**Replace Fuel Pump Delivery Module – Wave 6**

Campaign No. 2023070012, May 2024

Revision E: 08/05/2024

## **Replace Fuel Pump Delivery Module – Wave 6**

Figure 2

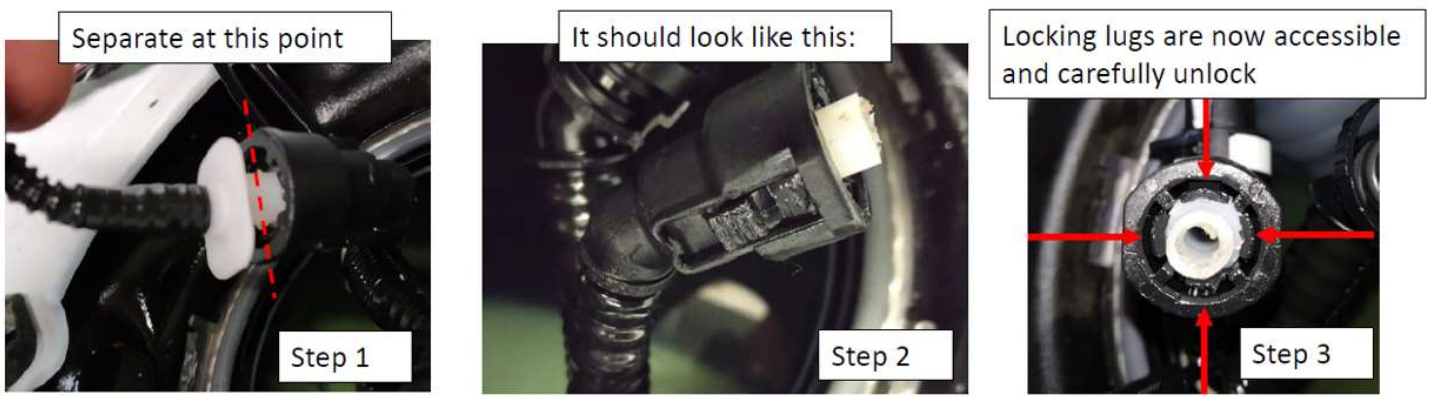
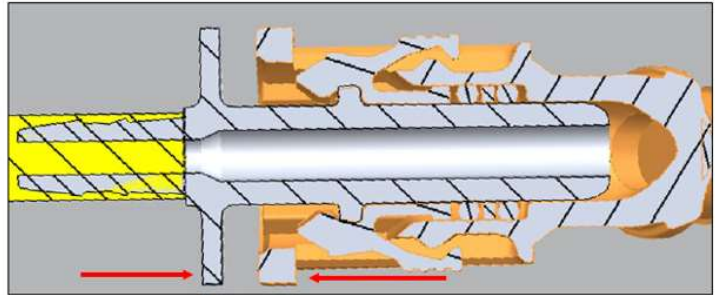
**i** Only model 206, 232: Note on disassembly of suction jet pump drive line quick connector. The procedure step 1-3 should only be performed when the quick disconnect is not working (**Figure 2**).

Squeeze the QC connection by at least 1mm, then unlock the latching lugs. If this is not possible. Step 1 -3

**Figure 3** (release corresponding connector and disconnect the contacts)

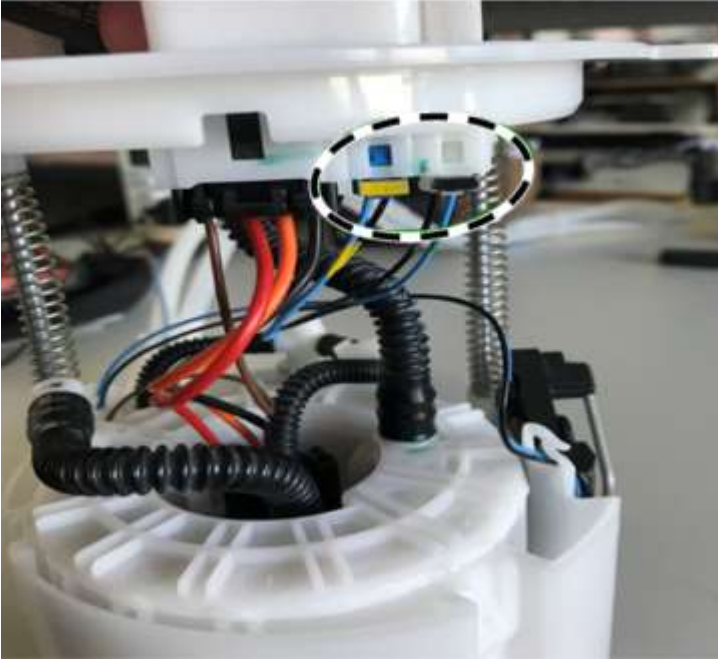
**i** Delivery modules that are delivered **without float-and-lever sensor** must be modified. (Figures 3-5)

**Figure 4** (remove lines from routing clip)

**Figure 5** (using a screwdriver, carefully push float-and-lever sensor housing away from module housing and at the same time push float-and-lever sensor housing upwards.)
